HISTORIC LANDMARK COMMISSION
JULY 30, 2012
NATIONAL REGISTER HISTORIC DISTRICT
NRD-2012-0086
Old West Austin
3301 Bryker Drive

Revise garage facade, add a front porch and construct a 650 sq. ft. rear addition on existing house.

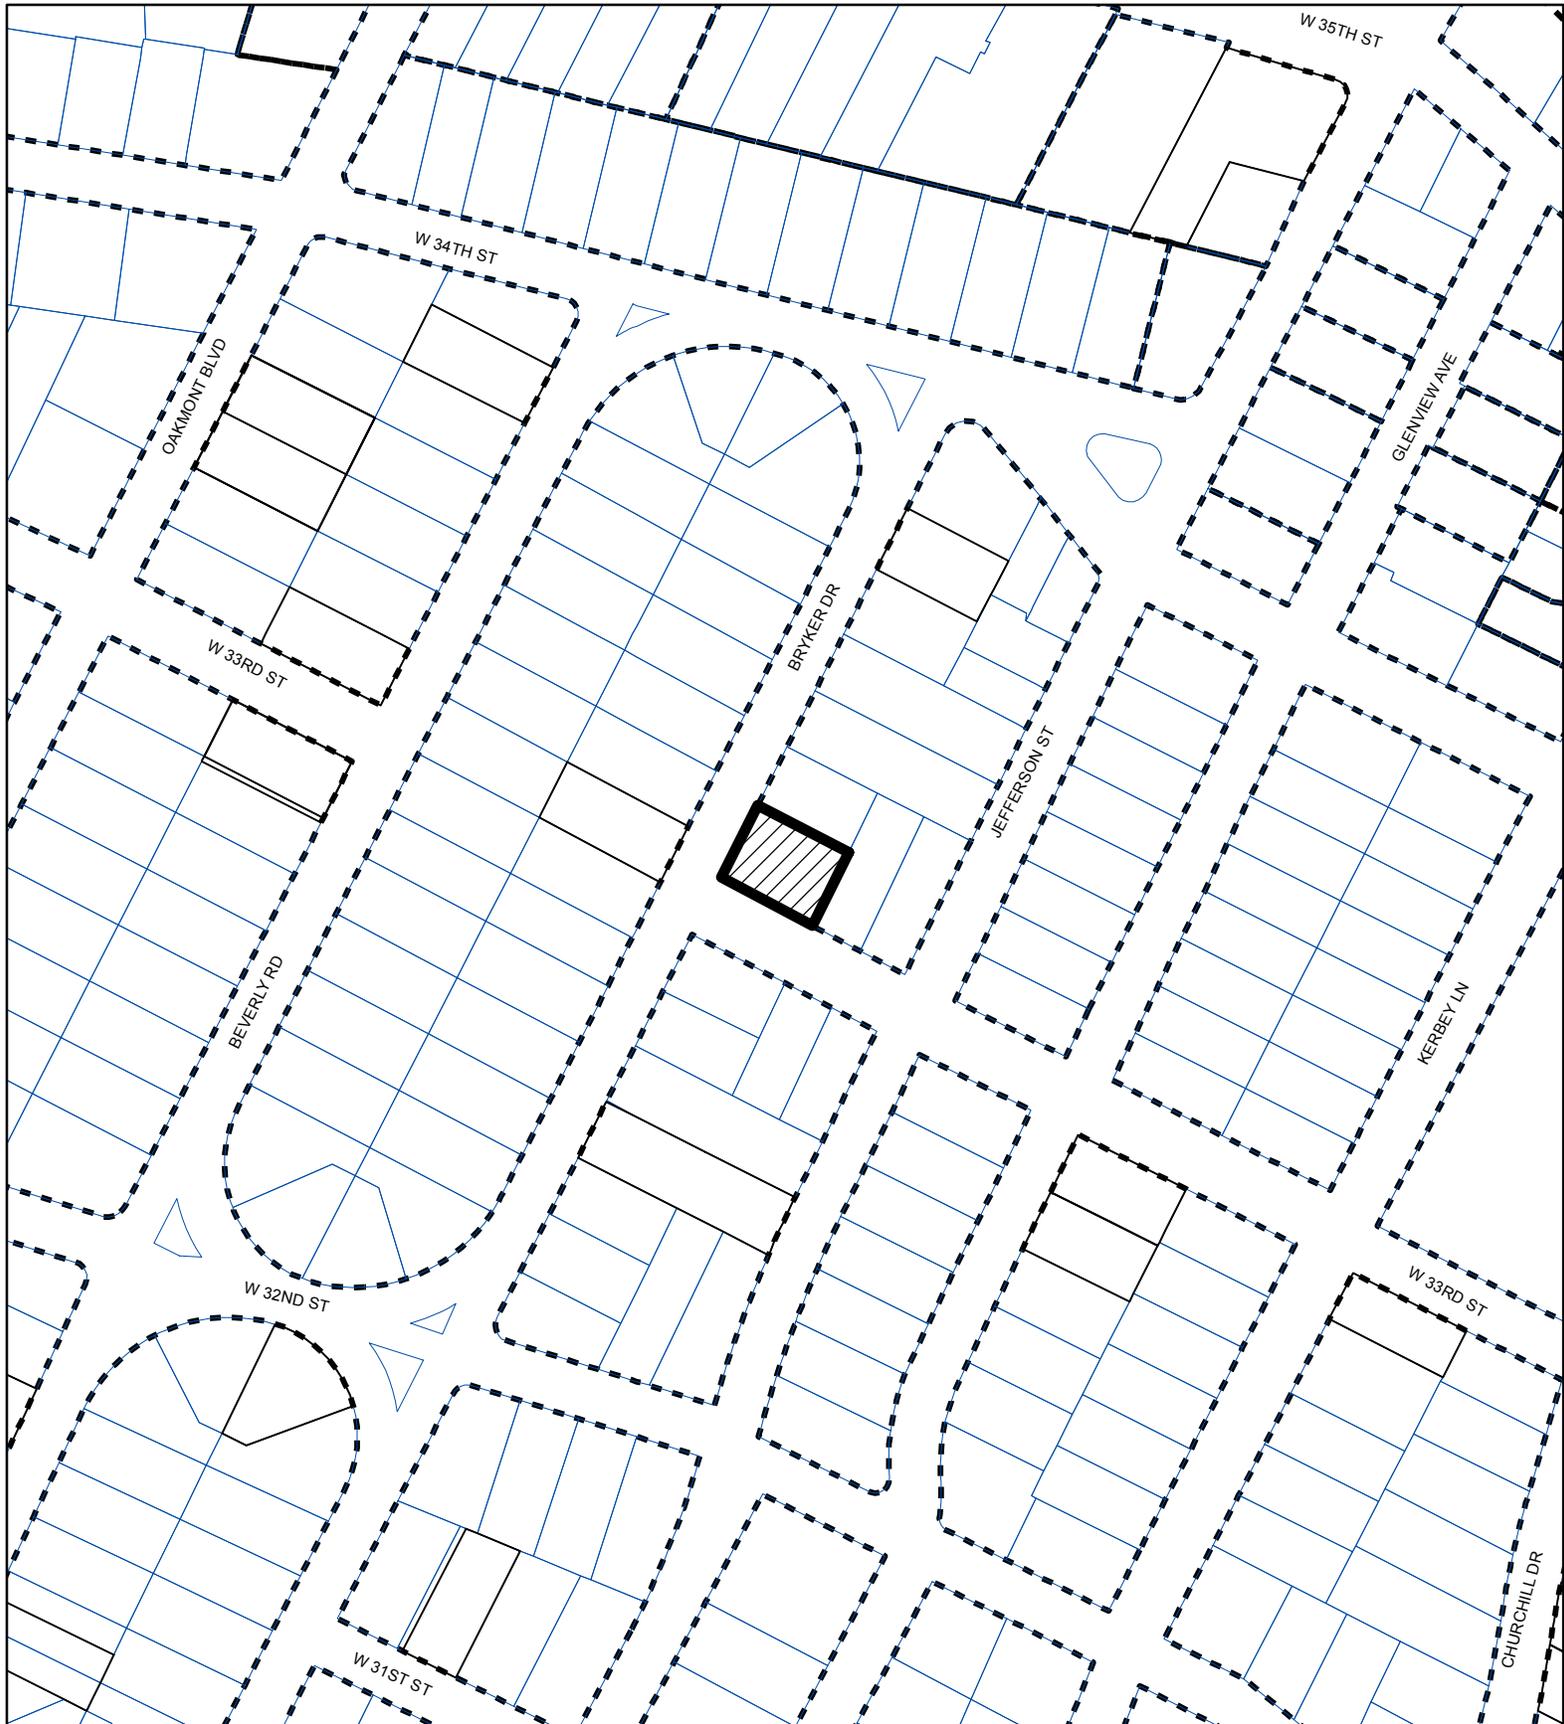
The design as proposed, although compatible with the architectural character and scale of the neighborhood, is a significant change to the appearance of the historic façade and would render the property non-contributing to the Old West Austin National Register District.

Release the building permit with the recommendation that the applicant consider revisions to the façade design that would maintain the properties contributing status. If the applicant pursues the proposed design, require submittal of a City of Austin documentation package.
